BUILDING PERMIT

Permit Number: 090243

has permission to Vacant space in basement establish use of space for classroom & research space w/ fit-up

City of Portland, Maine - Building or Use Permit Application

FOUNDATION PLAN/FRAMING PART PLAN @ VAULT & MEZZANINE OVER LOCKER ROOM
1/4"=1'-0"

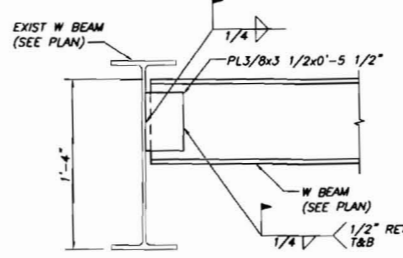
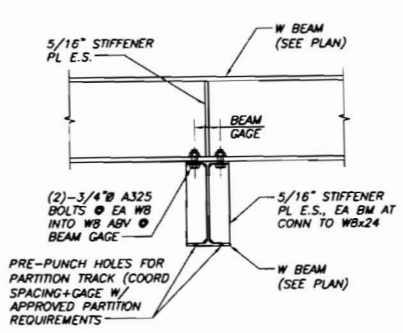
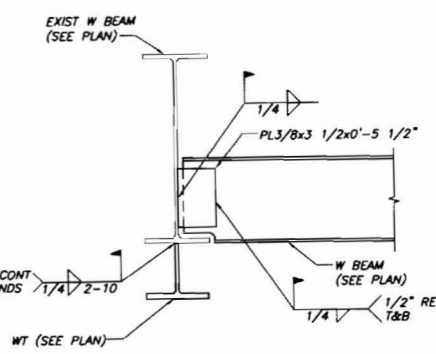
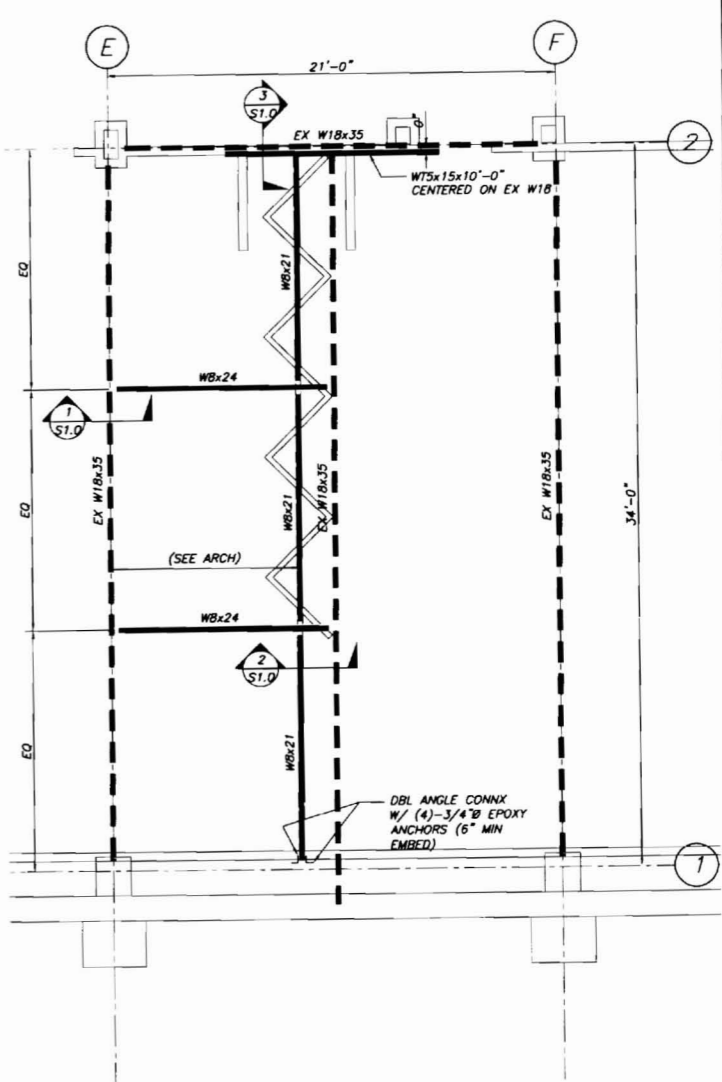
Mezzanine - 1. Egipt. Only - Access? ✓
2. Sprinkled spaces - ✓
A. Above Vault ✓
B. Mezz Area. ✓
C. Sprinkler Plan for ✓
entire space? ✓

Fire Marshall permit, → ✓

Sep. Sprinkler + Alarm permit required

**EMERGENCY
CODE PLAN**

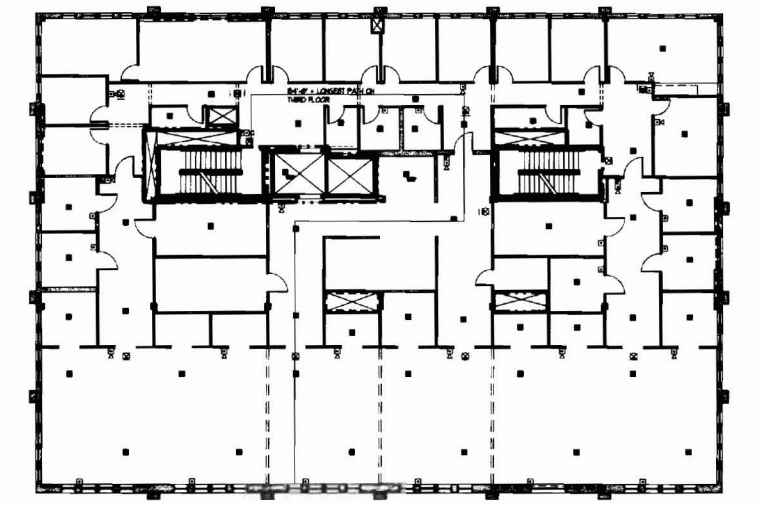
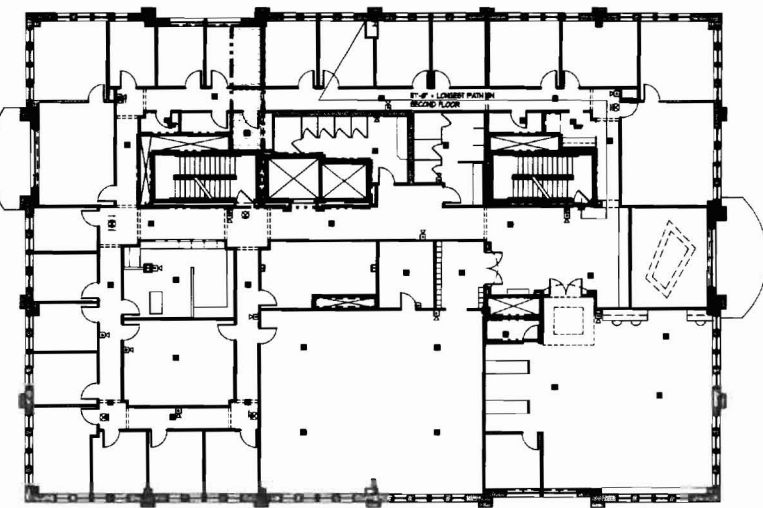
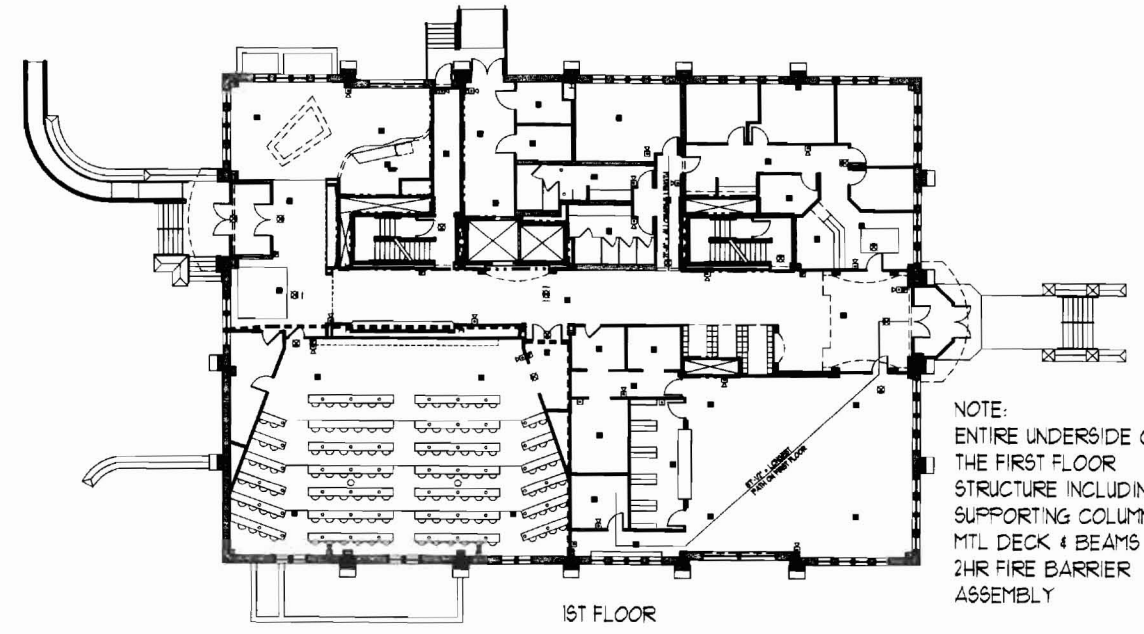
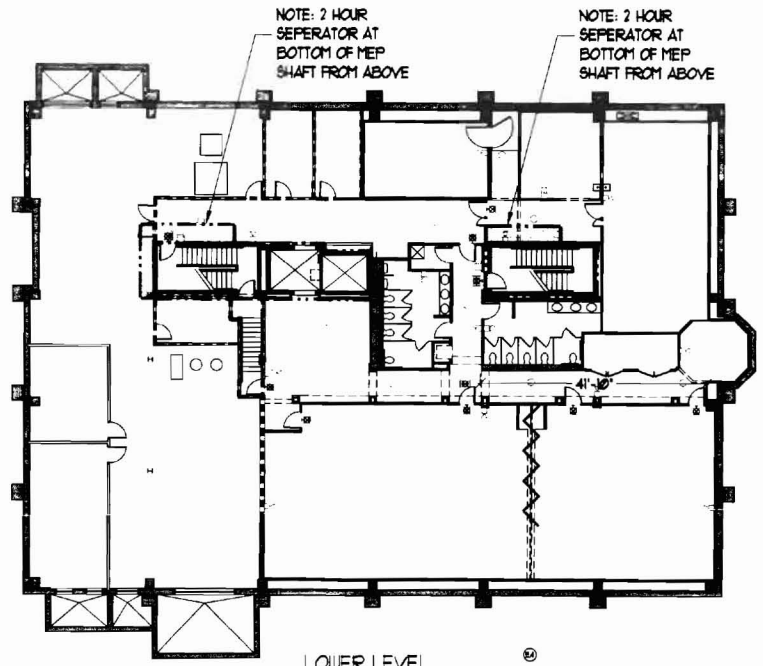
1. Generator + Gas tanks - Protection? → Hazard (size of tanks)
2. STORAGE AREA - O29
What? contents
3. Clean Room - use - OCC Load -
4. Total OCC load. UNSTD or IBC
5. Area Mod. - IBC 506.2 ST fanboys add 75%
Show calculations.

6 Bath fixtures - 172 UNE
CODE justification 194 IBC (20 net) -
#S.

200 35 = 5 WC - Female
215 4 WC - Men } 2 Urinals.

M $200 \div 40 = 5$ - 5 urinals.
F $200 \div 30 = 7$

Divide by 2

215 max occ. load.

Male
W.C. (1 per 40) = 5
Urinals (1 per 35) = 6
Lav. (1 per 40) = 5

female
Lav
W.C. - (1 per 30) = 7
Urinals - = 5

5
6
5
7
5
= 2 O.K.
